FERGUSON TOWNSHIP PLANNING COMMISSION
Regular Meeting Agenda
Monday, December 12, 2022, 6:00 PM

1. MP Machinery and Testing at 2161 Sandy Drive Preliminary Land Development Plan

SUBJECT: MP Machinery and Testing at 2161 Sandy Drive Preliminary Land Development Plan

RE: MP Machinery and Testing Preliminary Land Development Plan

TRANSITION: EXTRUDED CURB TO STRAIGHT FACE CURB & GUTTER
 NOT TO SCALE
 P05013

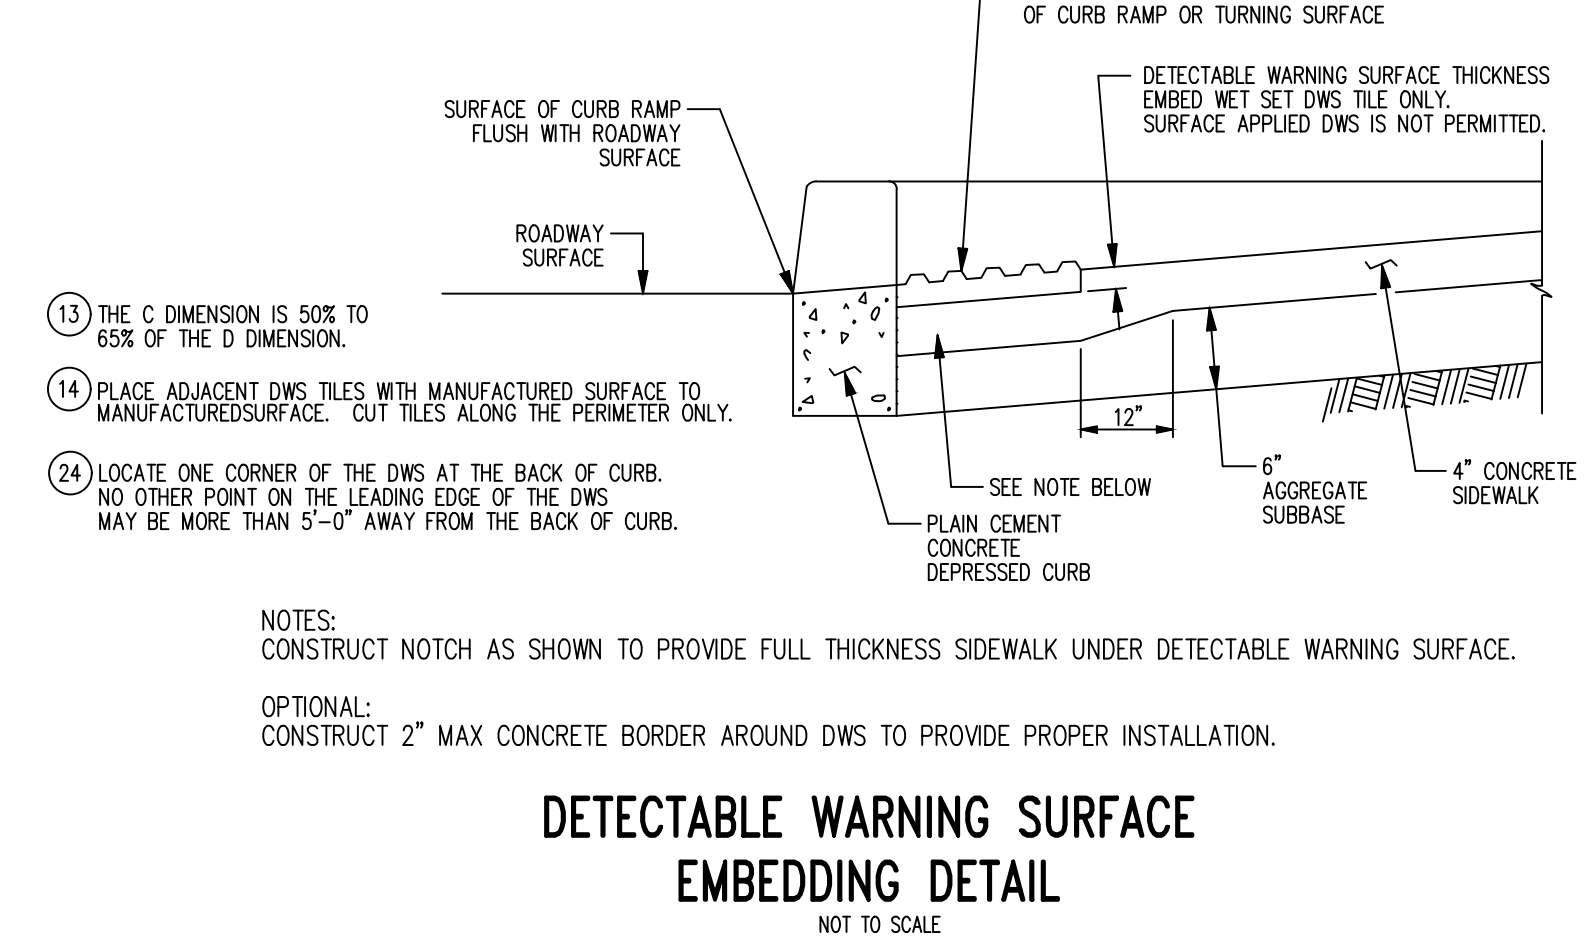
9. Please label the existing detail of Depressed Concrete Curb to be for handicap sidewalk ramp. Not resolved. The response indicates it is labeled, but the plan did not change. 11-28-22; not resolved. The response indicates it is labeled, but the label of the detail on sheet 10 did not change.
Updated. See Sheet 10; we added the (*)NOTE.

10. Please provide a detail for the depressed curb/gutter for driveway. Not resolved. I cannot locate a detail for depressed curb/gutter for the driveway on Sheet 9. 11-28-22; not resolved. The following items need corrected on both provided details for curb-gutter:

- a. The depressed curb should specify 1 ¼", not ¼".
Updated. Refer to Sheet 10.
 - b. Since the gutter pan cross slope was labeled to match existing, the specified slope of ½" per foot should be removed.
Updated. Refer to Sheet 10.

- c. Since the gutter pan width was labeled to match existing, the overall width of the curb and gutter should be removed.
Updated. Refer to Sheet 10.
11. Please provide a detail for the connection between the concrete curb/gutter and the driveway curb. Not resolved. I cannot locate a detail on Sheet 9. 11-2-22; not resolved. This requested detail is not on the plans. 11-28-22; not resolved. This requested detail is not on the plans. The detail would show how the driveway curb connects to the street curb in a monolithic manner.
Provided. Refer to the TRANSITION: EXTRUDED CURB TO STRAIGHT FACE CURB & GUTTER on Sheet 10.
